Sewerage Impact Assessment Report
with Response-to-Comment

Section 12A Rezoning Application for Proposed Columbarium on Various Lots in D.D.41, Sha Tau Kok, New Territories

Sewerage Impact Assessment Report

Reference: P036/03 Issue 3

The assessment findings demonstrated and confirmed that there should be sufficient sewage capacity for the public sewers along Sha Tau Kok Road – Shek Chung Au even though there is a change of sewage generation due to the Proposed Development.

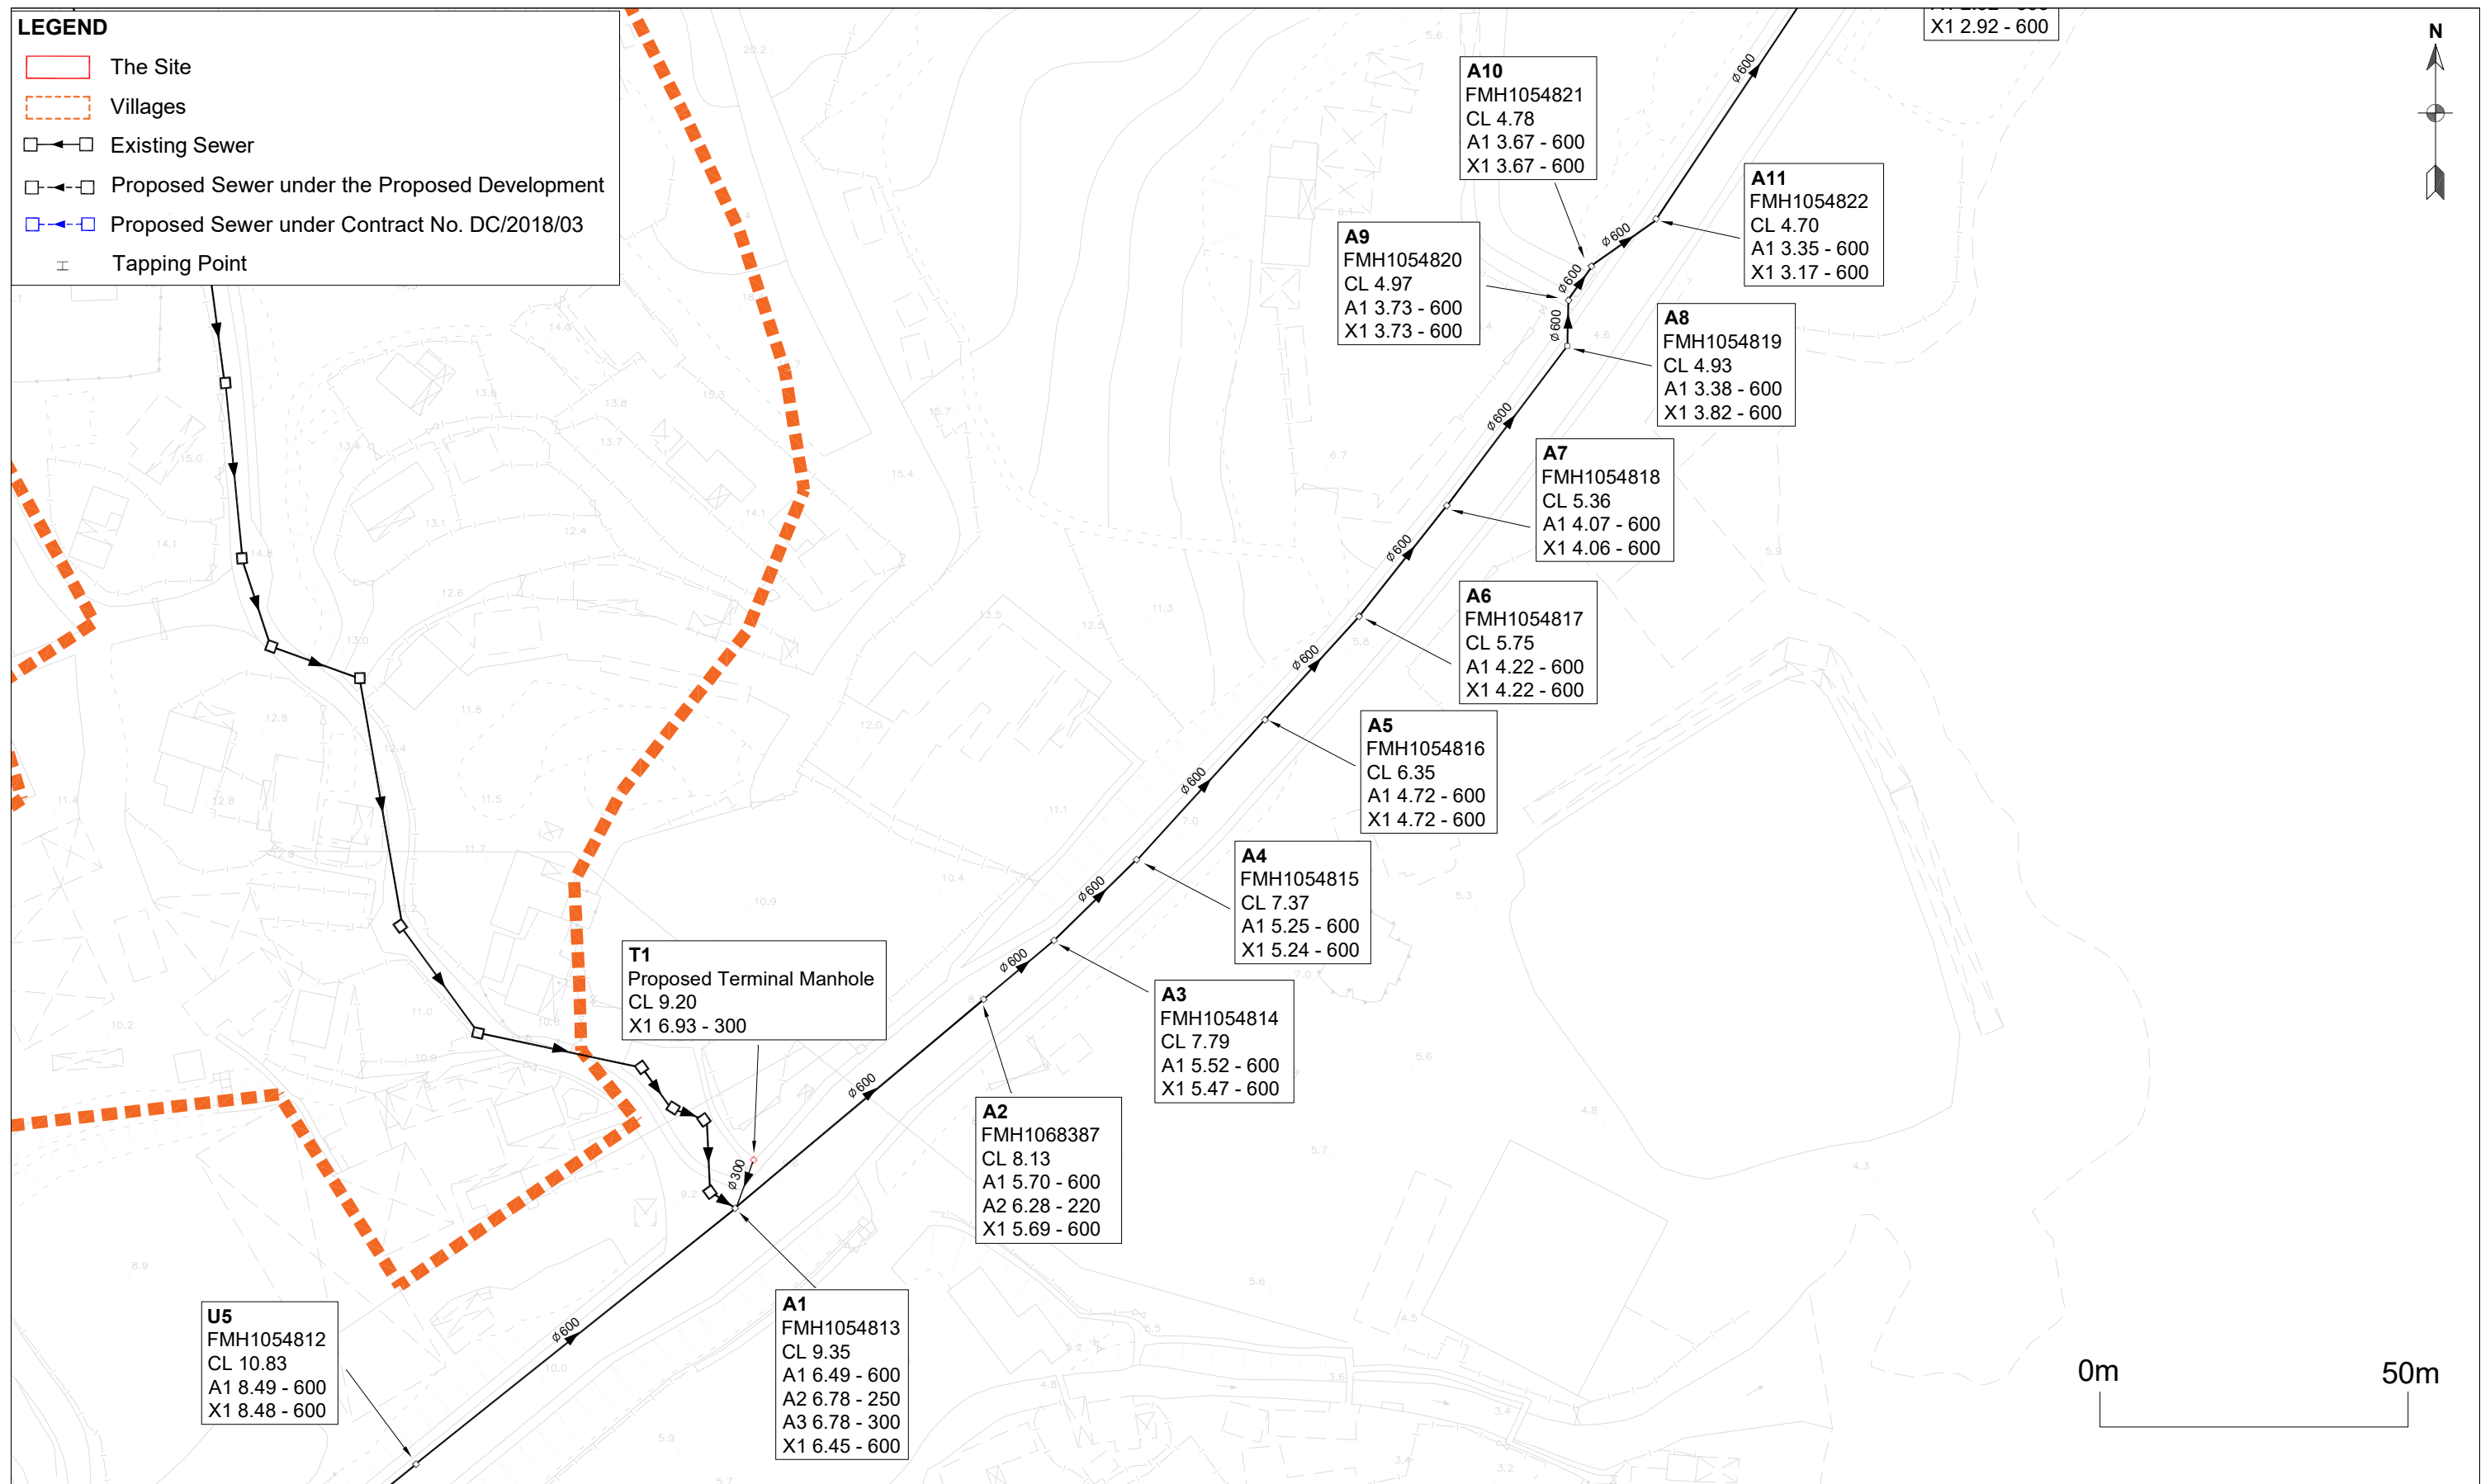
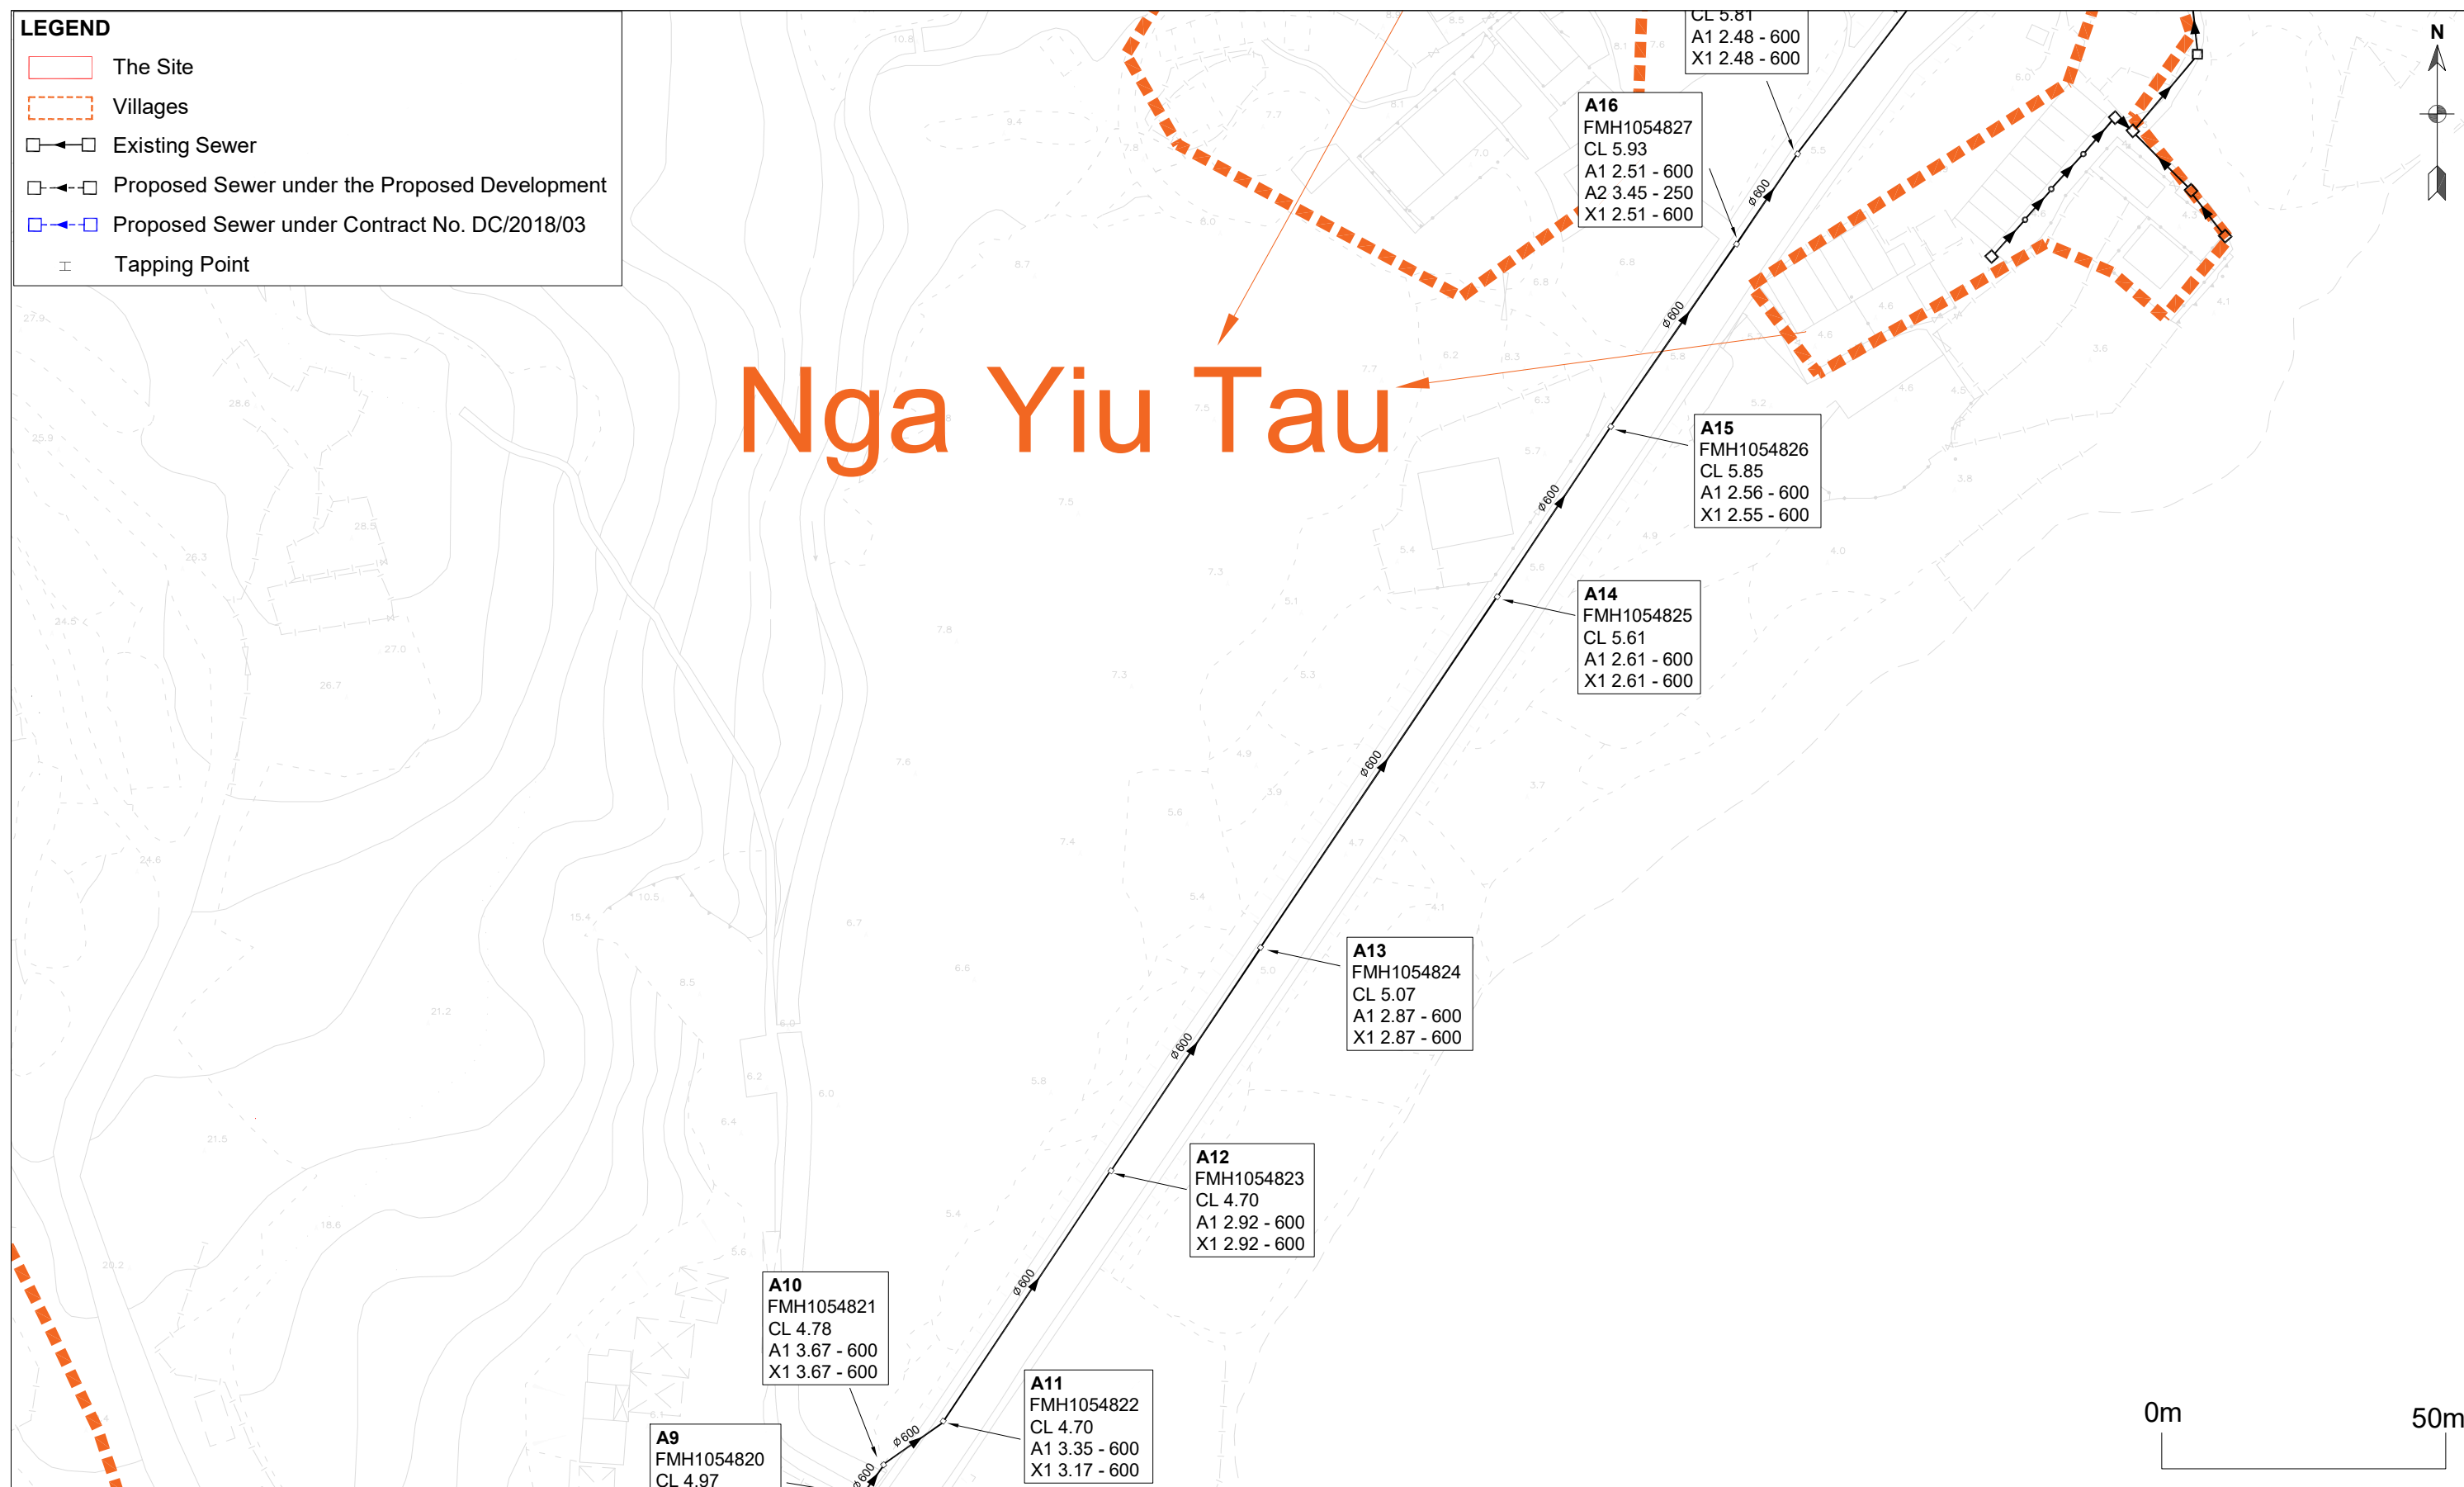
Items	Comments	Response
Comments on Sewerage Impact Assessment from DSD		
a	This SIA report needs to meet the satisfaction of EPD, the planning authority of sewerage infrastructure.	Noted.
b	The applicant should check and ensure that the existing sewerage system to which the proposed connection will be made have adequate capacity and satisfactory condition to cater for the additional discharge from the site. He should also ensure that the flow from this site will not overload the existing sewerage system.	Noted.
c	Figure 3.1 should show the alignment of all existing public sewerage network in the vicinity of the site. The applicant should ensure that a 3m clear distance between the proposed structure and the existing public sewerage network would be maintained.	Noted. Figure 3.1 shows the alignment of existing public sewerage networks along Sha Tau Kok – Shek Chung Au. It is confirmed that a distance of more than 3m between the proposed structure and the existing public sewerage network is maintained. Please refer to Figure 3.1.

d	Consideration should be given to adopt polyethylene (PE100) pipe for buried sewage pipe beyond the sewage terminal manhole.	Noted. Polyethylene (PE100) pipe will be adopted.
e	The location of the terminal manhole shall be designed and constructed close to the lot boundary as far as practicable.	Noted and revised. The location of the terminal manhole has been designed to be as close to the lot boundary as possible. Please refer to Figure 3.1.

Comments on Sewerage Impact Assessment from DSD		
1	Figure 3.1 has not shown the alignment of all existing public sewerage network in the vicinity of the site (e.g. the sewerage system at Tong To). The applicant should review.	Noted and updated. Please refer to Figure 3.1.
2	RtoC item h: Please update section 5 regarding the handover arrangement of sewerage pipe to DSD. Please note that DSD would only consider taking up the maintenance of connection pipe located downstream of the terminal manhole and outside the private lot boundaries after satisfactory technical audit by DSD. The applicant should be responsible for the maintenance of pipes constructed under this development which have not been handed-over to other parties for maintenance.	Noted and revised. Please refer to Section 5.
3	Unless the applicant can submit satisfactory DIA and SIA reports, I do not support the application.	Noted.
